**Subject:** MHI's Second Responses to US-APWR DCD RAI No. 776-5851 Revision 3 (SRP 03.07.02)

Responses to Request for Additional Information No. 776-5851,  
Revision 3

**US-APWR Design Certification  
Mitsubishi Heavy Industries  
Docket No. 52-021**

**RAI NO.:** NO. 776-5851 REVISION 3  
**SRP SECTION:** 03.07.02 – Seismic Systems Analysis  
**APPLICATION SECTION:** 3.7.2  
**DATE OF RAI ISSUE:** 06/15/11

Figure 1 Depiction of Lindley-Yow Response Spectrum

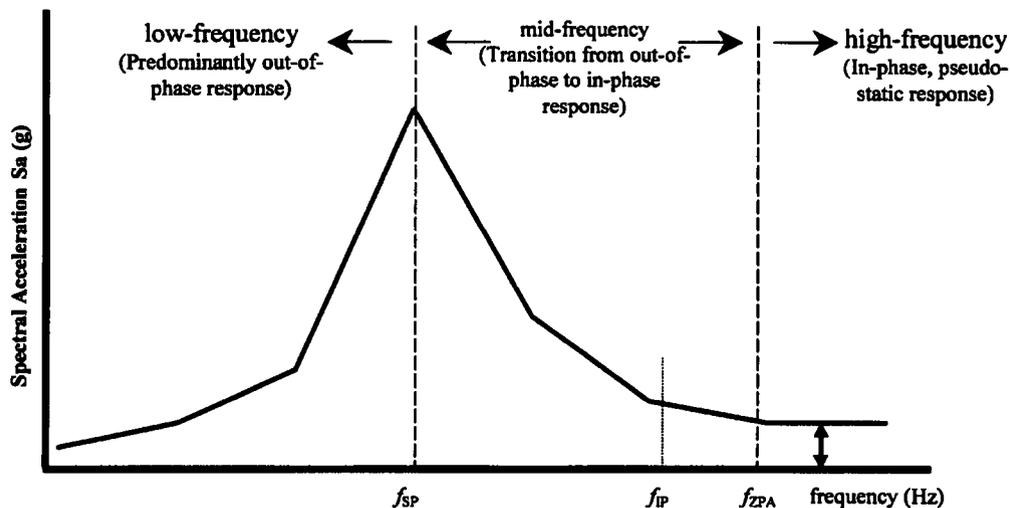
In Subsection 5.2.3 of MUAP-11001 (R0), "Combined Modal Responses: Lindley-Yow Method," the paragraph (page 63) states, "The periodic response portion of the Lindley-Yow method is implemented by using ANSYS "Grouping Method" and the rigid response portion is implemented by using "Static ZPA Method" per Regulatory Position 1.4.2 of RG 1.92, Rev. 2. The directional effect from each direction is combined by 100-40-40 method."

The staff noticed that so far the Applicant has not reported the use of the Lindley-Yow method for combining modal responses in the DCD (Rev. 3) and in seismic analyses reports of various category I structures and the Turbine building. The applicant is requested to discuss the unique circumstances and aspects of the A/B seismic analyses that require the use of Lindley-Yow method for combining modal responses. In RG. 1.92, one limitation on the use of Lindley-Yow's method is specified, "The Lindley-Yow's method should not be used for SSCs that have natural frequencies less than the frequency of the lowest-frequency spectral acceleration peak."

Thus, the applicant is requested to discuss the effect of the Lindley-Yow's method limitation on the seismic analyses responses. The Applicant is also requested to discuss how the periodic response component is combined with the rigid response portion and provide the technical basis and justification for the combination used.

The seismic response is calculated using the Lindley-Yow method described in NRC Regulatory Guide 1.92, and in NUREG/CR-6645. The Lindley-Yow method divides the total seismic response into two components: response in-phase with the ground motion and response out-of-phase with the ground motion.

A typical seismic response spectrum can be divided into three regions as shown in Figure 1 below. Defining  $f_{SP}$  as the frequency corresponding to the peak spectral value on the response spectrum curve and  $f_{ZPA}$  as the frequency corresponding to the zero-period ground acceleration (ZPA), the regions can be categorized as follows:

- Modes having a frequency less than  $f_{SP}$  (low-frequency range) are predominately out-of-phase with the ground motion and thus have no contribution to the in-phase response.
- For modes having a frequency between  $f_{SP}$  and  $f_{ZPA}$  (mid-frequency range), there are contributions to both the in-phase and out-of-phase responses.
- Modes having a frequency greater than  $f_{ZPA}$  (high-frequency range) are in-phase with the ground motion.

The total in-phase response is calculated by performing a static analysis in which the zero period ground acceleration (ZPA) is applied to the total in-phase mass. This procedure automatically accounts for the so-called "missing mass", or that portion of the structural mass that does not participate in the amplified modal responses.

The out-of-phase response is determined by performing a response spectrum analysis combining the response of modes having a frequency less than or equal to the frequency corresponding to the ZPA ( $f_{ZPA}$ ). Modified spectral accelerations,  $S'_{ai} = S_{ai} \sqrt{1 - \alpha_i^2}$  are used in the analysis, where  $S_{ai}$  equals the unmodified spectral acceleration for mode "i". For modes which have a frequency less than  $f_{SP}$  (low-frequency range) and are predominately out-of-phase with the ground motion,  $\alpha_i = 0$ , which specifically addresses the limitation on the use of the Lindley-Yow method discussed in Regulatory Position C.1.3.2 of RG 1.92. For modes having a frequency between  $f_{SP}$  and  $f_{ZPA}$  (mid-frequency range),  $\alpha_i = ZPA/S_{ai}$ . Out-of-phase modal responses are summed using the Grouping method. The lowest dominant frequency of the AB structure in each direction (x,y and z direction) is greater than  $f_{SP}$ .

The total seismic response is calculated as the SRSS of the in-phase and out-of-phase components.
